1. **13700 24th Street E Donut and Commercial Design Review.**

REPORT TO THE DESIGN COMMISSION
from the DEVELOPMENT SERVICES DEPARTMENT

Permit Number: DR-2023-0008

Project Components: Design Review for construction of a new commercial shopping center and site improvements on a 2 acre site including parking, landscaping and pedestrian space.

**RENDERED LANDSCAPE PLAN**

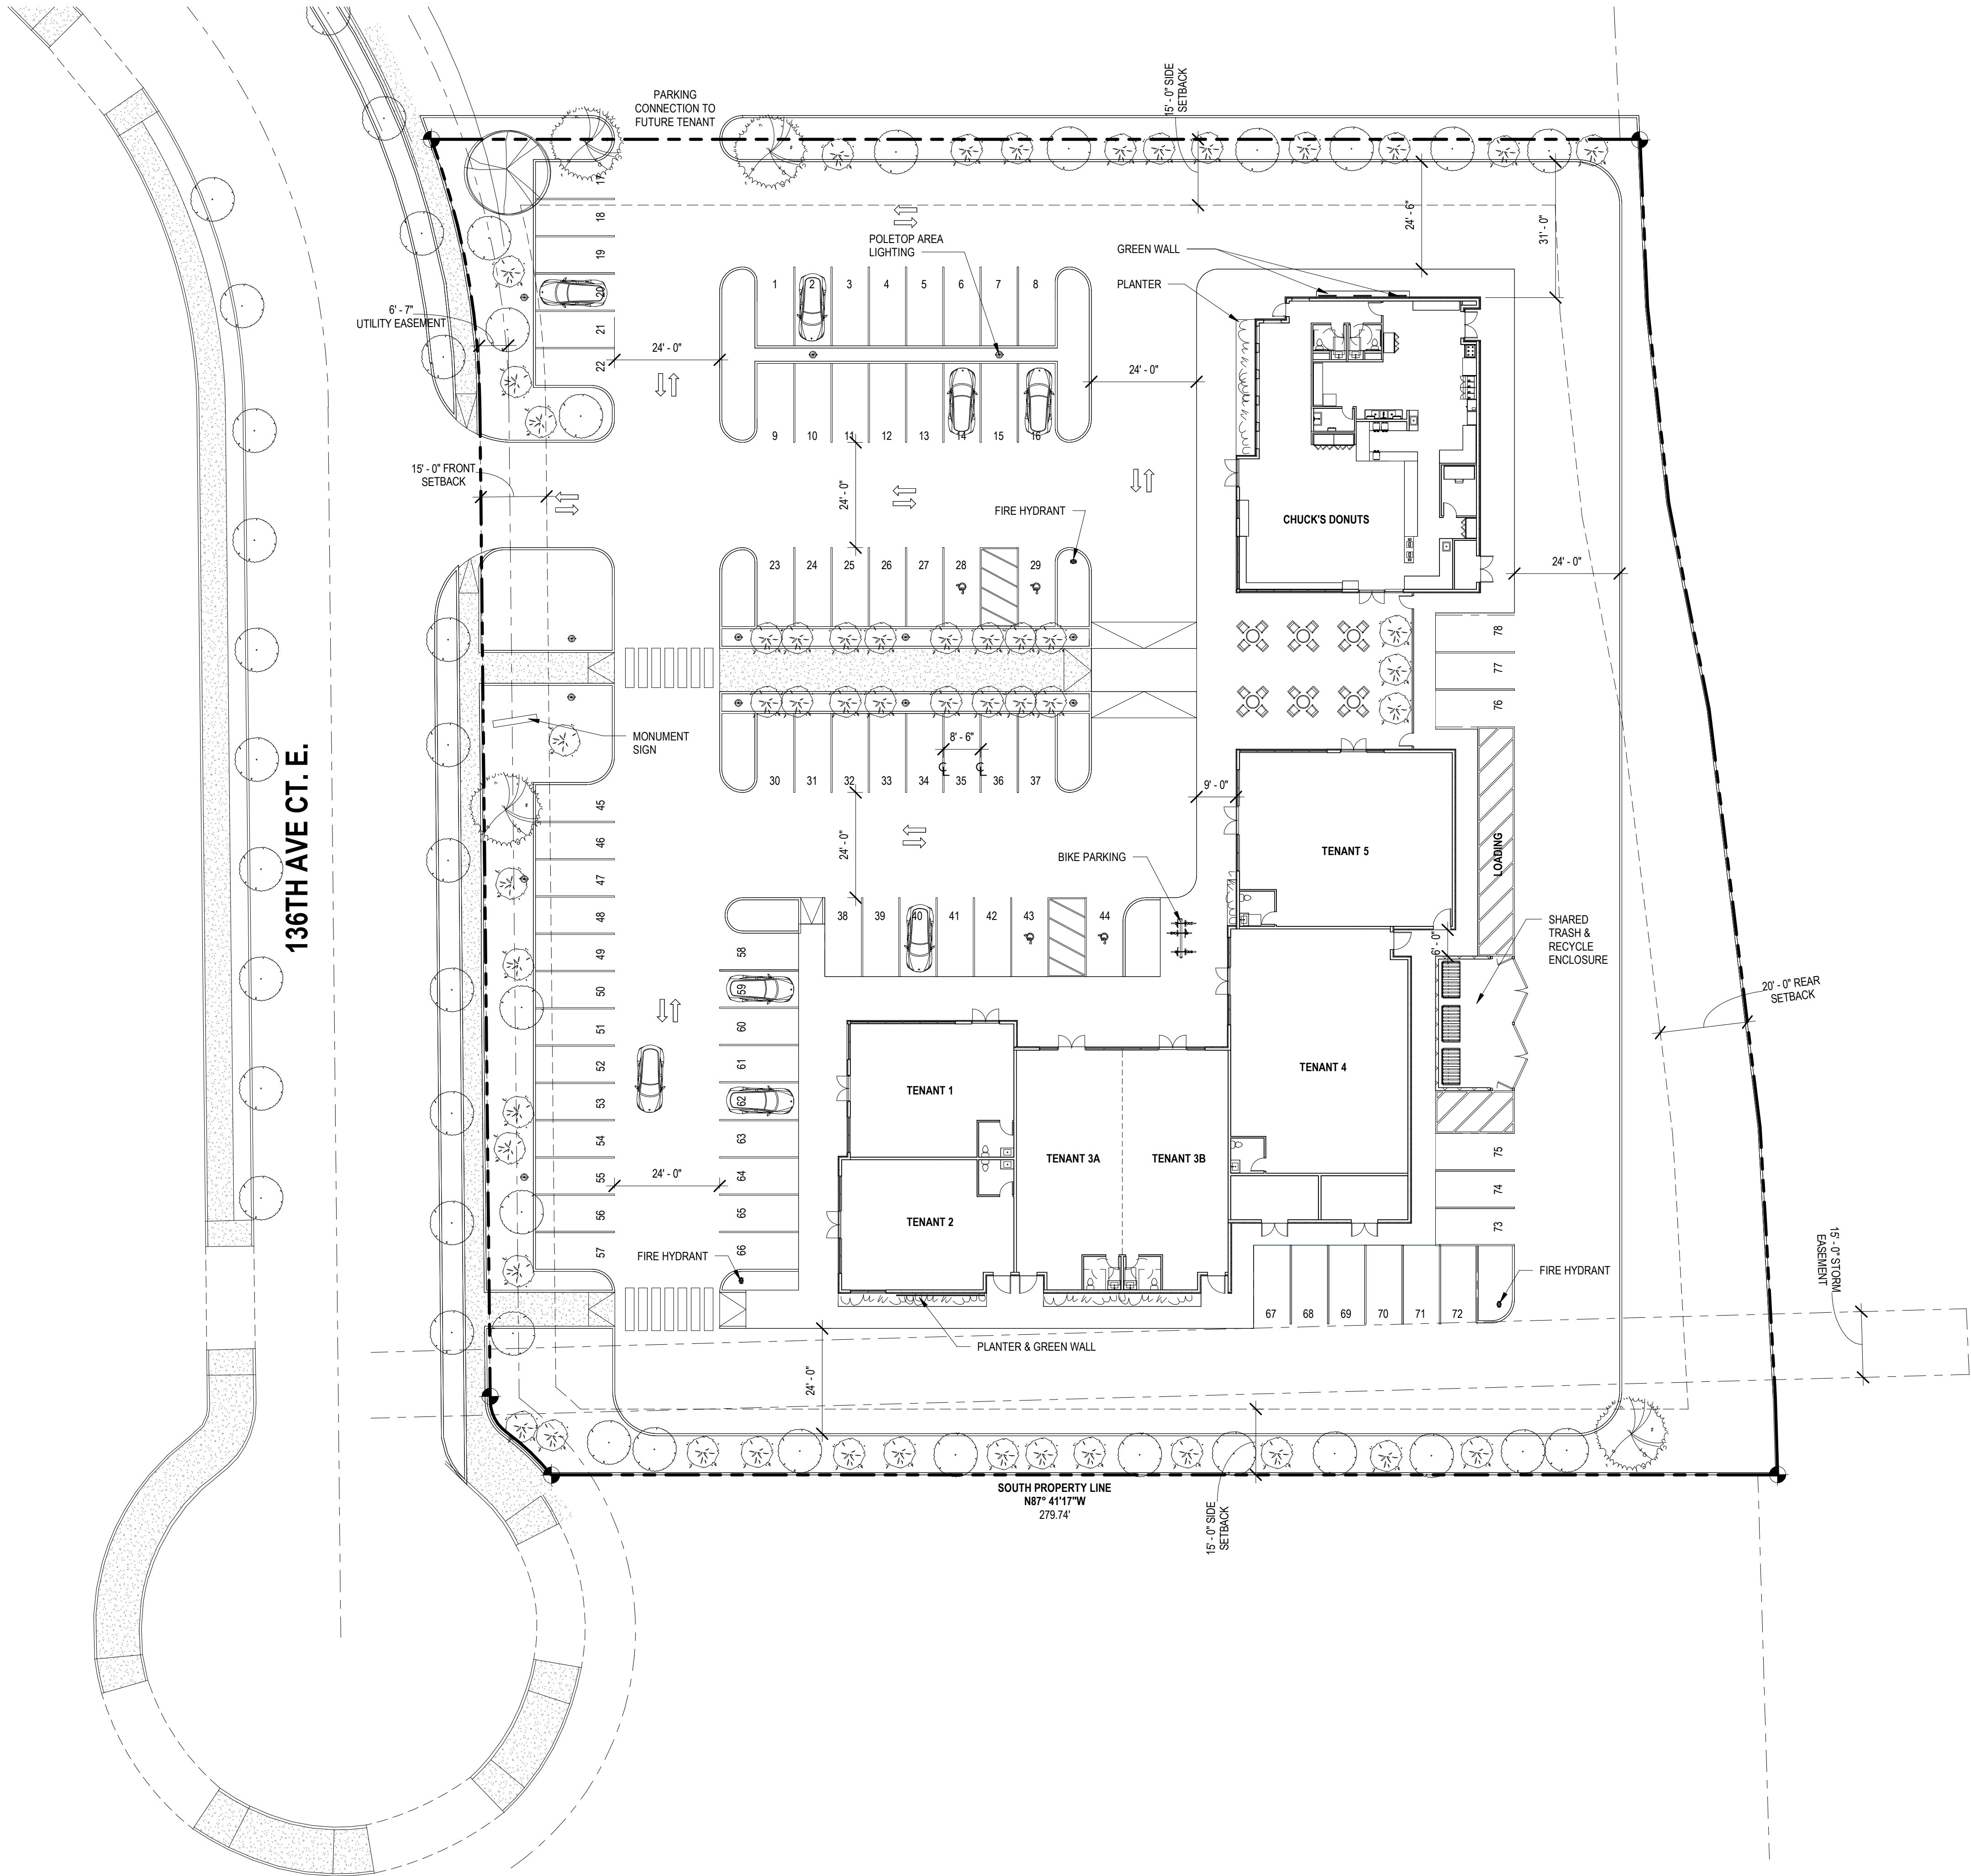
This project contains its pedestrian oriented space abutting the south side of the donut shop and acts as a courtyard connecting the two buildings. This space is connected to each building and the sidewalk through well thought out connection points. The primary access from the sidewalk includes a wide walkway with perimeter landscaping and a trellis feature to highlight and invite people into the site. The size of site and building would require 1,846 square feet of pedestrian oriented space and this proposes approximately 5,670 square feet; however, some of that includes areas that are also required walkways, but still provides ample space per this guideline. A condition of approval does look at adding some landscaping or buffer element between the drive aisle and the seating area. This guideline is met as conditioned.

Landscape planters should be added along the western edge of the pedestrian space. This will ensure that the pedestrian spaces is screened and protected from the drive aisle and parking area.

1 SITE PLAN
1" = 20'-0"

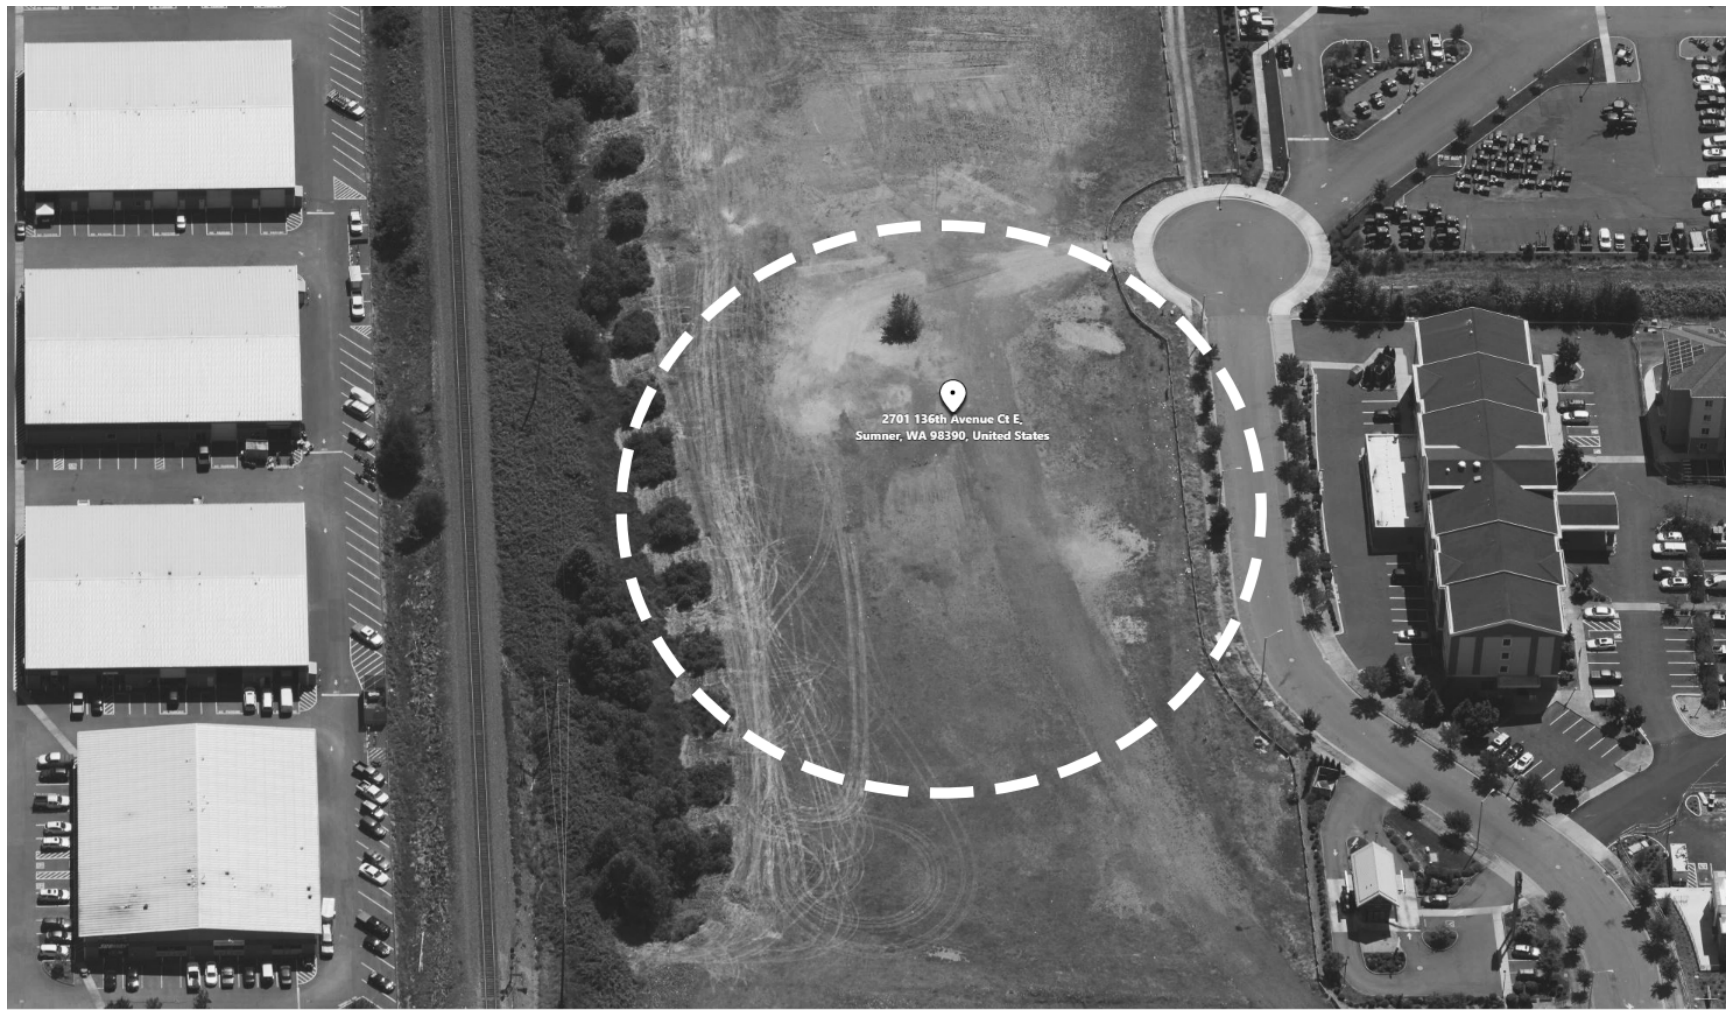
The parking configuration for this site created challenges, the intent is to bring the building close to the street or orient them towards the street, provide shared access, provide efficient vehicular circulation, provide adequate parking and provide pedestrian access and amenities. Staff and the applicant reviewed multiple other building and site layouts and found the current proposal best met the intent of the guidelines. The project has approximately 300' of frontage and would therefore have a maximum of 225' of vehicular use along the frontage, the proposal shows 105' of non-vehicular frontage which would leave 195' of vehicular frontage and therefore meet the 75% maximum. All vehicular space is screened from the street through 10' of landscaping. This guideline is met.

This project proposes one driveway from 136th and a stubbed out connection to the north that will allow for a future connection between this site and the site to the north. This guideline is met.

This project provides a well laid out parking lot and access for vehicles and pedestrians alike. The layout allows both vehicles and pedestrians to access from 136th through separate points to promote safe circulation and reduce pedestrian conflict. The proposal also allows for future connection to the north. This guideline is satisfied.

This project includes pedestrian access and circulation throughout the site including access from the sidewalk on 136th. Condition # 1 requires that the shown pedestrian walkways are constructed of a contrasting paved surface and encourages a stamped and or stained product.

The pedestrian walkways shall be constructed of a contrasting paving material to provide durable safe walkways and promote safety between vehicles and pedestrians. It is encouraged to use a stamped and or stained material leading to the pedestrian court.
